MORGAN / HARBOUR
CONSTRUCTION

**Re: 703-723 W. Algonquin Rd – PUD Amendment – Amendment to PUD Ordinance 18-014 PC#20-016
– Round 2**

The following is our Planning Commission response Letter addressing the comments as outlined in the Village of Arlington Heights Building & Life Safety Department Interoffice Memorandum regarding the aforementioned project:

HAMILTON PARTNERS ARLINGTON HEIGHTS INDUSTRIAL
ARLINGTON HEIGHTS, ILLINOIS
CONSTRUCTION DETAILS AND STANDARDS - PHASE 2 (FRITO-LAY)

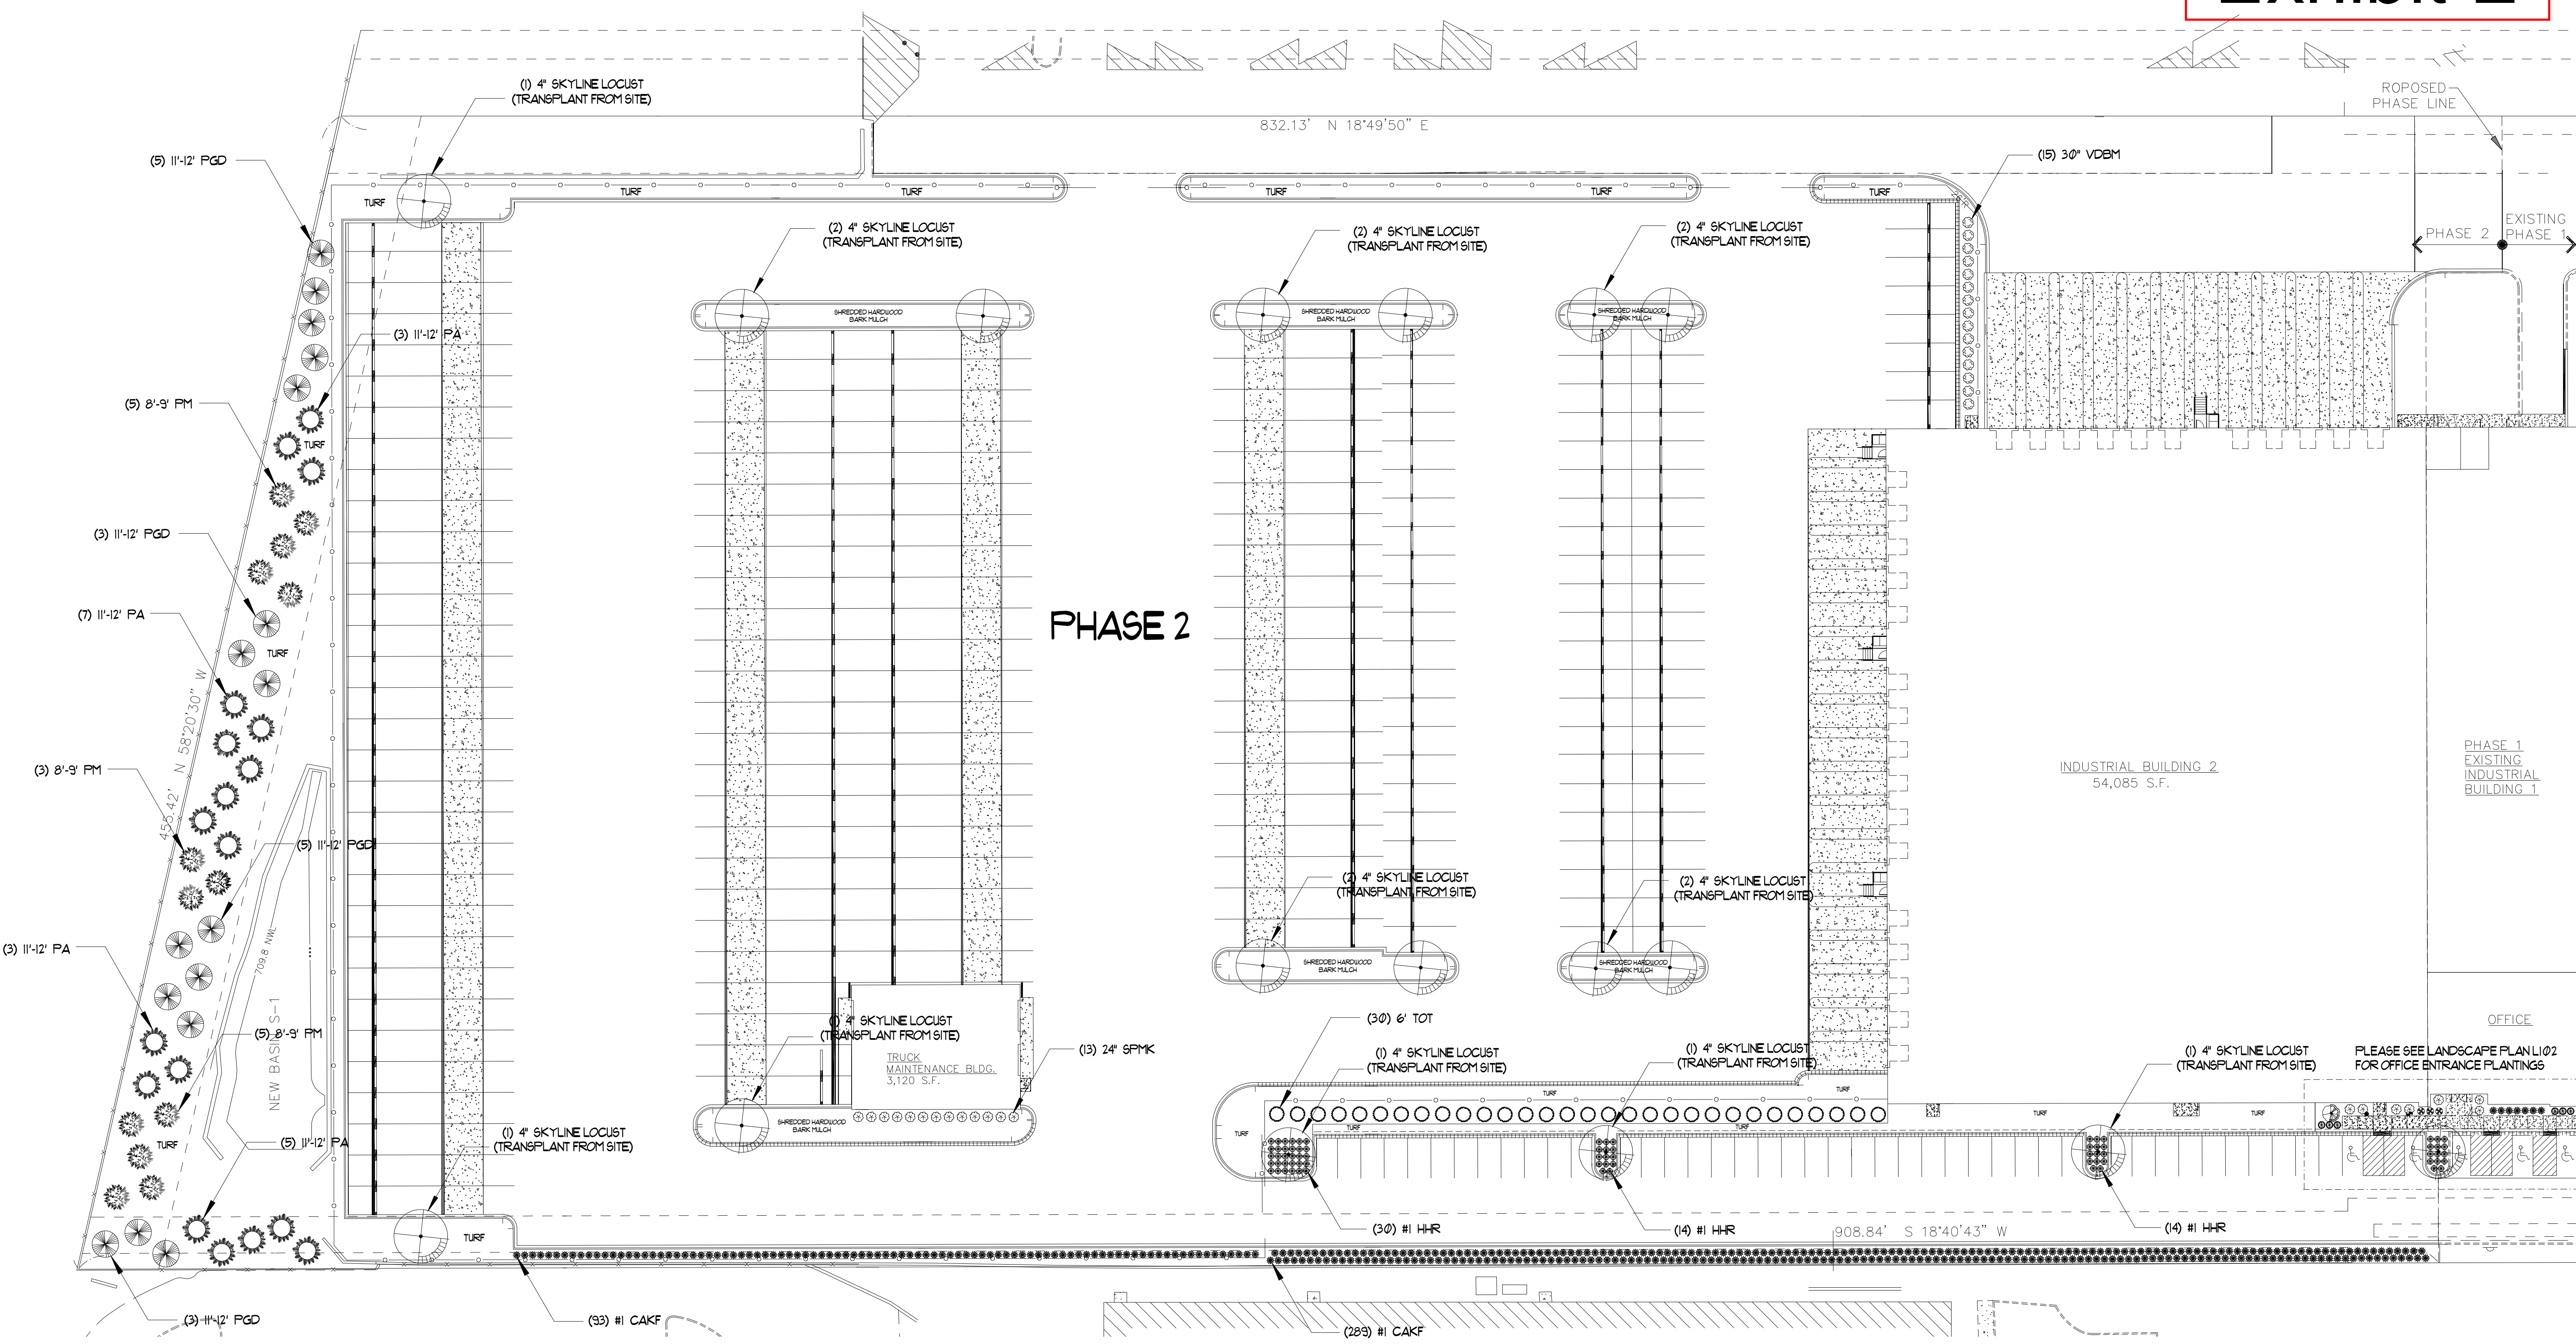
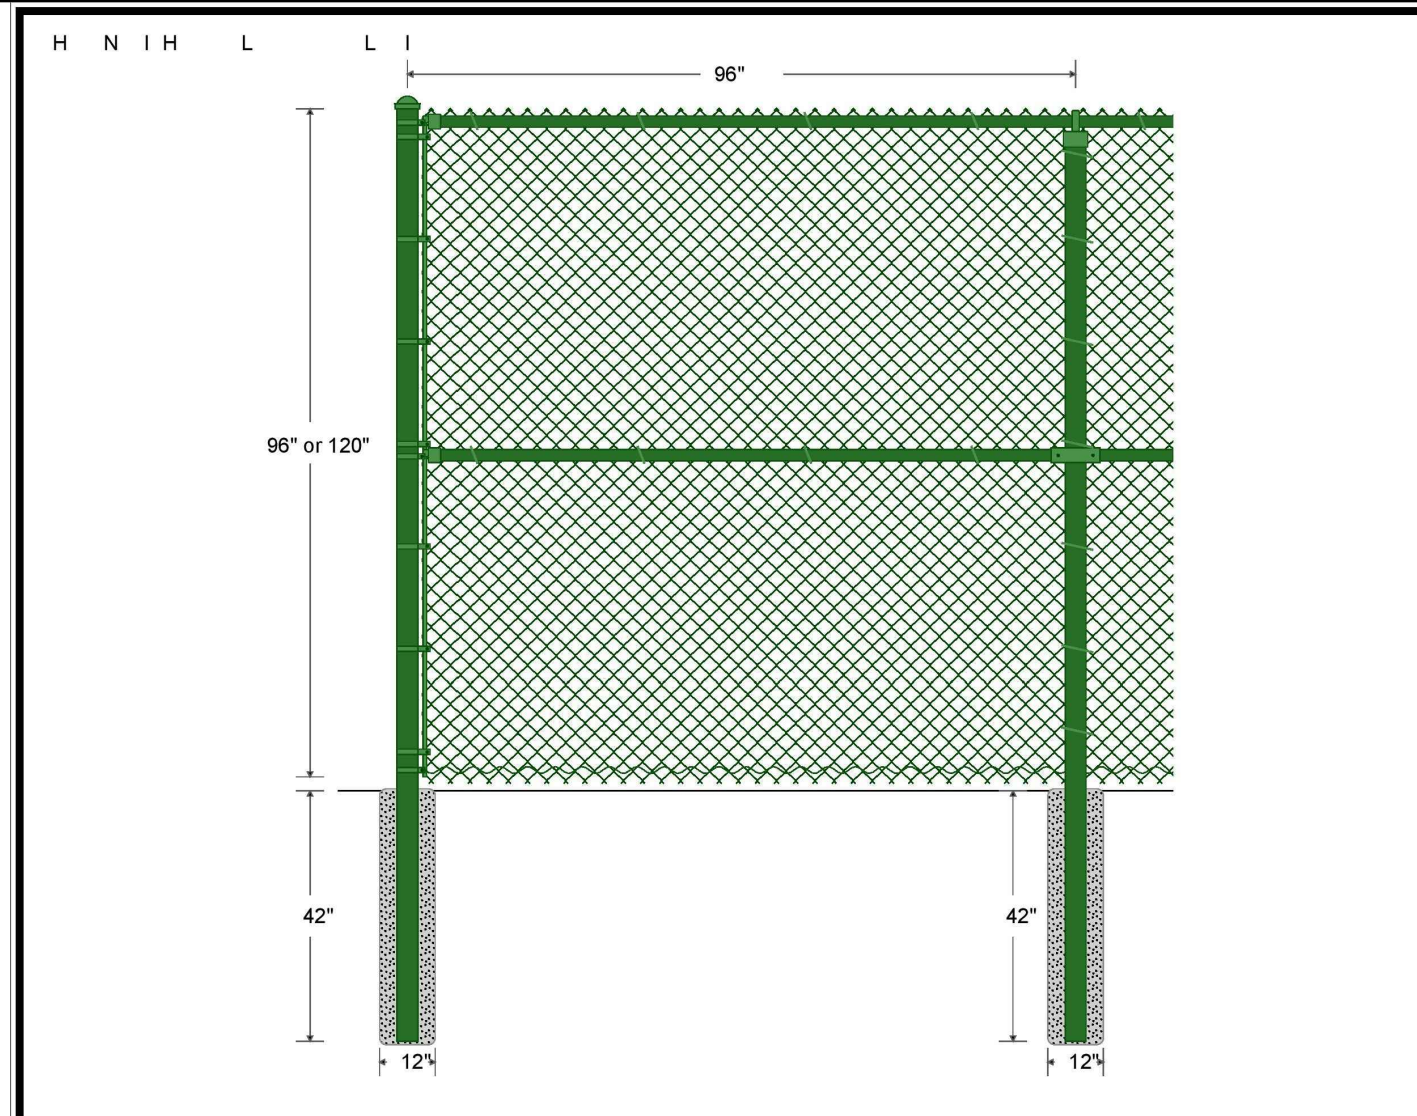
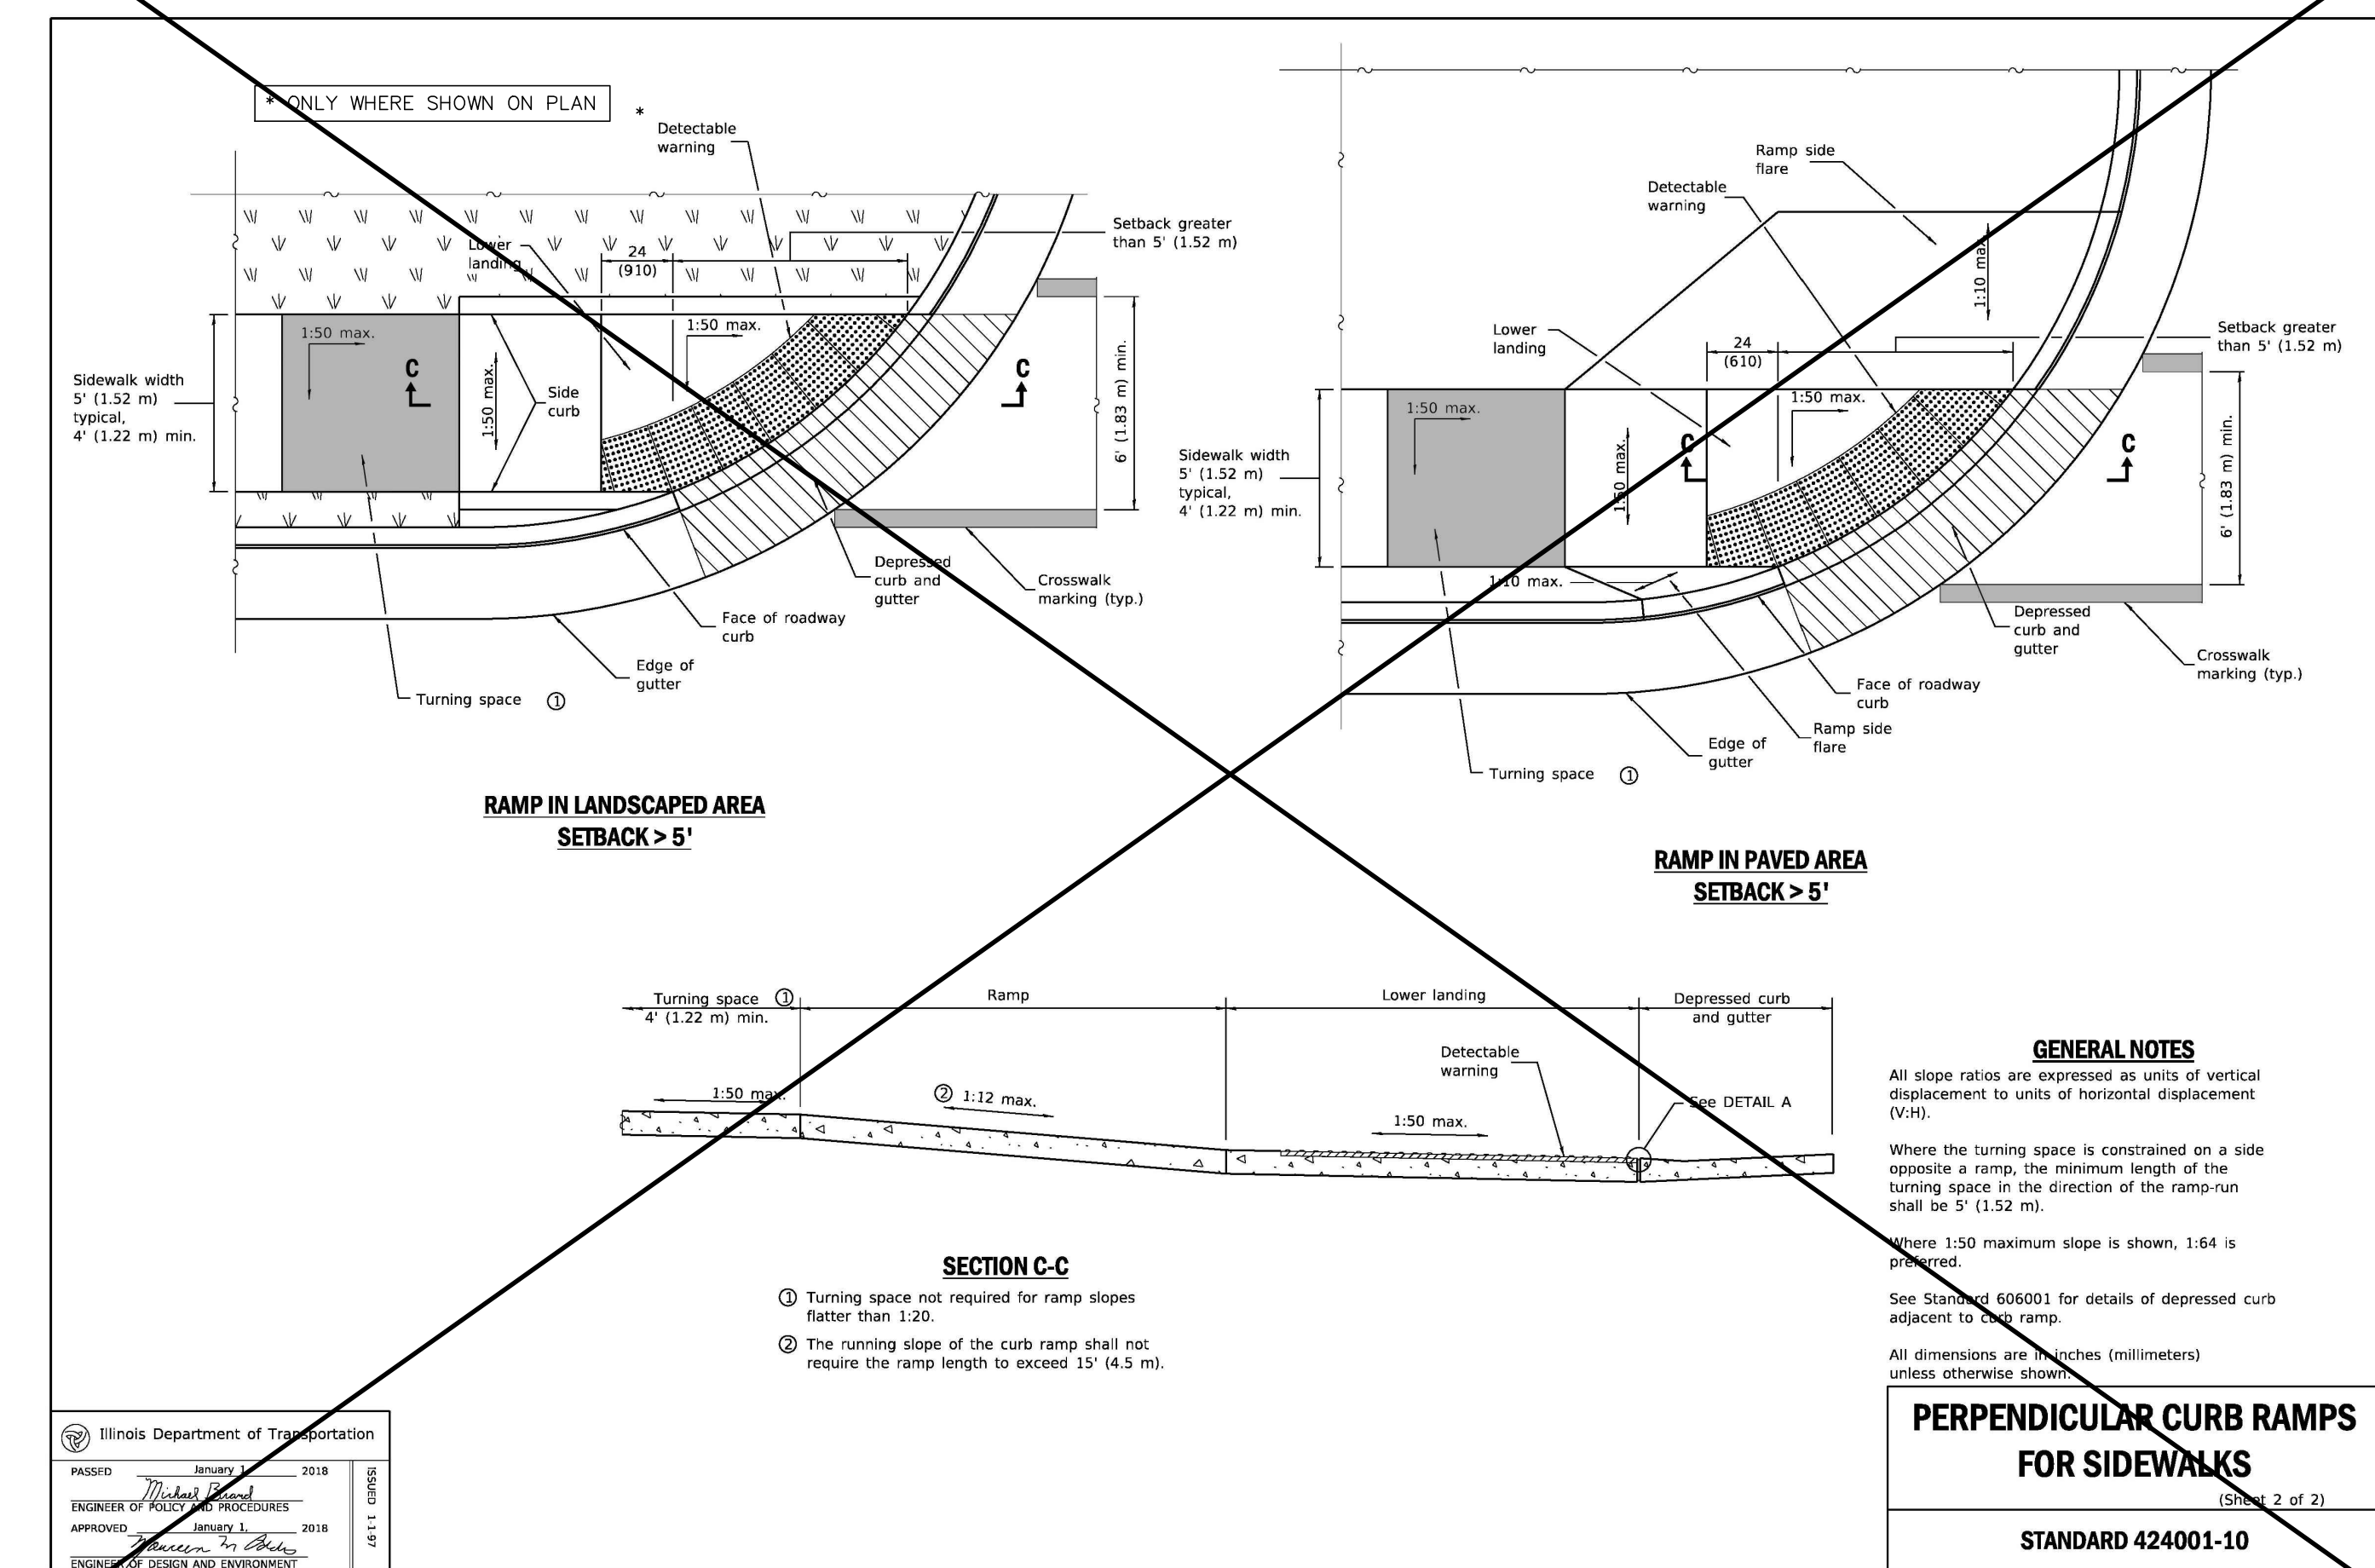
25. **Response:** Noted
26. **Response:** Revised engineering sheet is included (Exhibit D). For the variation request see above response to #21 f. Included are the cutsheets for the "Hedgelink" fencing product (Exhibit B) which would be for both 8' and 10' sections as the previously proposed product is not available at 10' height.
